THE PROBLEM SOLVER®**PROBLEM:****OE ball joint fails prematurely**

SOLUTION:**MOOG® Problem Solver®
Lower Ball Joint K3199/K80767**

**K3199 shown**For parts lookup, visit www.FMe-cat.com

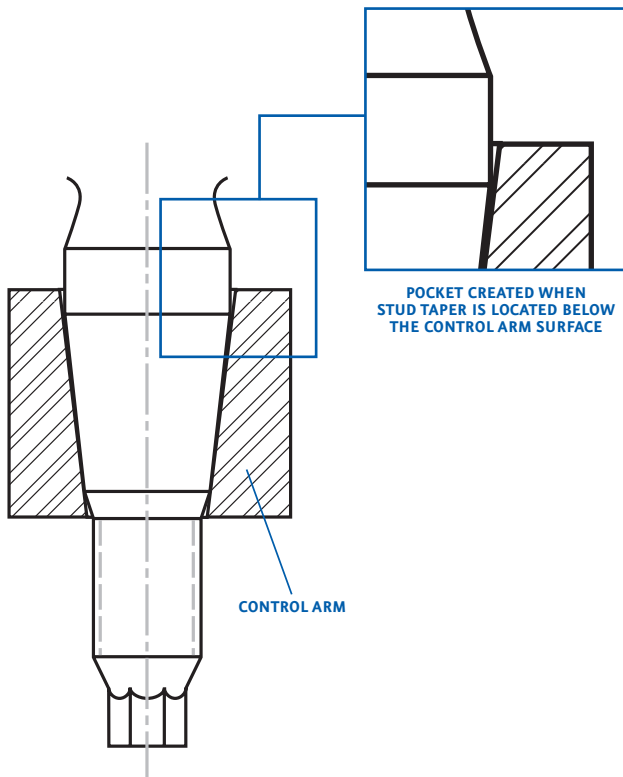
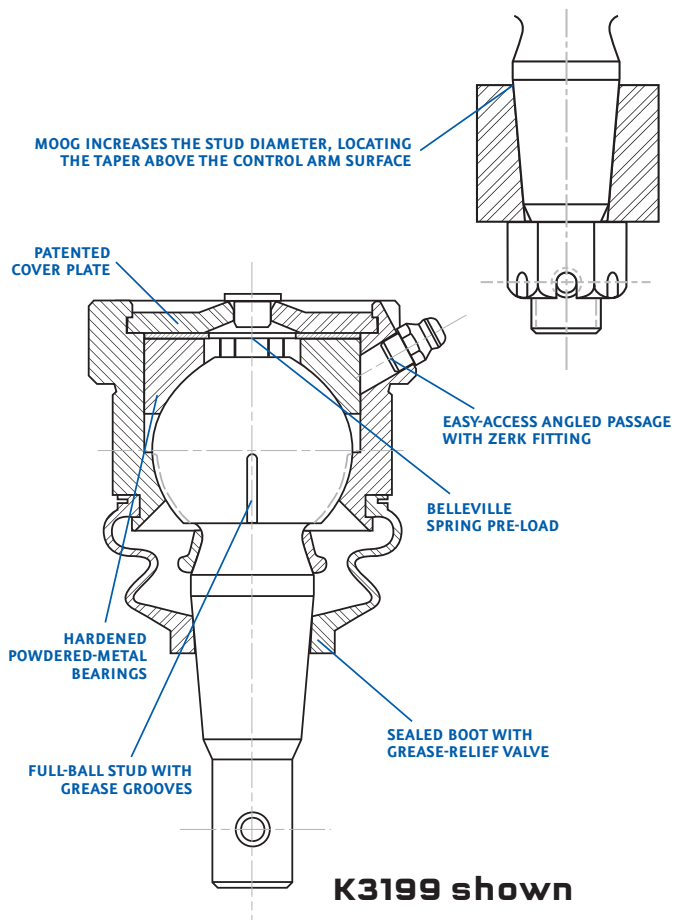
Ball joint boot failures can cause corrosion, accelerated wear and possible joint separation. Failure can be traced to a slight gap between the ball joint stud and control arm. The gap or pocket accumulates moisture, promoting corrosion of the ball joint stud and control arm tapered hole. The corrosion generated by the pocket penetrates under the dust boot, wearing at the sealing surface of the boot. Once exposed to the elements, the sealed, non-serviceable ball joint quickly degrades and fails.

- MOOG® Problem Solver® K3199/K80767 has been designed with a larger stud shank diameter, which in turn creates a larger stud taper diameter. This locates the stud taper above the surface of the control arm, allowing complete contact with the control arm tapered hole, eliminating the gap.
- A sealed boot with a special grease-relief valve provides a sealed, serviceable environment.
- An angled passage (with Zerk fitting) in the side of the housing provides easy access for service; a MOOG exclusive.
